Access Compliance Report

Public Rights-of-Way

(Curb Ramps)

Intersection ID: 31684	Main Street: HYACINTH_CT	Cross Street: WILLIE_WORRELL_DR	Location: NW
ADA ID: 80505F6DECF9	Ramp Type: PerpDiag	Initial Pass/Fail: Fail	Overall Compliance: No
			Severity Score: 33.75

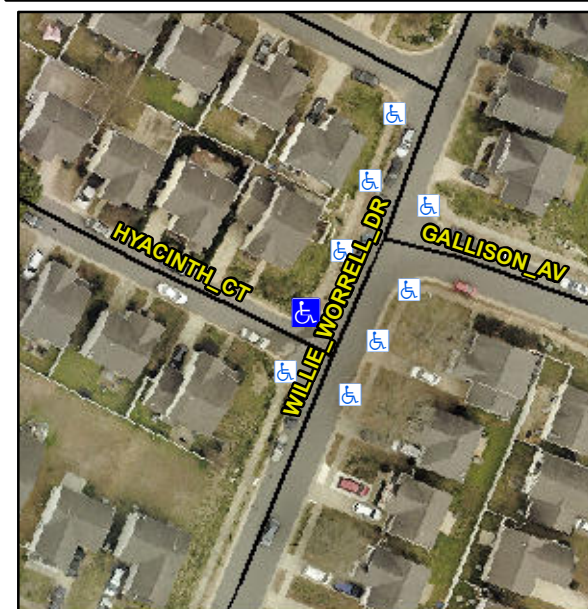
R304.5.1, R304.2.2, R304.5.3

Compliance	Description	Data	Compliance	Description	Data
N/A	Ramp Length (in)	47.0	No	Ramp Slope (%)	8.6
No	Ramp Width (in)	36.5	No	Ramp XSlope (%)	6.8
N/A	Flare Type LT	N/A	N/A	Flare Type RT	N/A
N/A	Flare Slope LT (%)	N/A	N/A	Flare Slope RT (%)	N/A
N/A	Flare Traversable LT?	N/A	N/A	Flare Traversable RT?	N/A
N/A	Landing Length (in)	N/A	N/A	DWS Provided?	N/A
N/A	Landing Width (in)	N/A	N/A	DWS Contrast?	N/A
N/A	Landing Slope (%)	N/A	N/A	DWS Length (in)	N/A
N/A	Landing X Slope (%)	N/A	N/A	DWS Full Width?	N/A
N/A	Landing Curb? (Y/N)	N/A	N/A	DWS Offset (in)	N/A
N/A	Shared Landing?	N/A			
N/A	Gutter Ponding?	N/A	N/A	Gutter Slope (%)	N/A
N/A	Gutter Lip Ht (in)	N/A	N/A	Gutter X Slope (%)	N/A
N/A	Painted X Walk1?	No	N/A	Painted X Walk2?	No
	X Walk 1 Direction	To SW		X Walk 2 Direction	To SE
N/A	X Walk 1 Width (in)	N/A	N/A	X Walk 2 Width (in)	N/A
	X Walk 1 Slope (%)	4.5		X Walk 2 Slope (%)	2.6
	X Walk 1 X Slope (%)	0.2		X Walk 2 X Slope (%)	3.1

Remove & Replace Curb Ramp With Two New Directional Ramps or Equivalent.
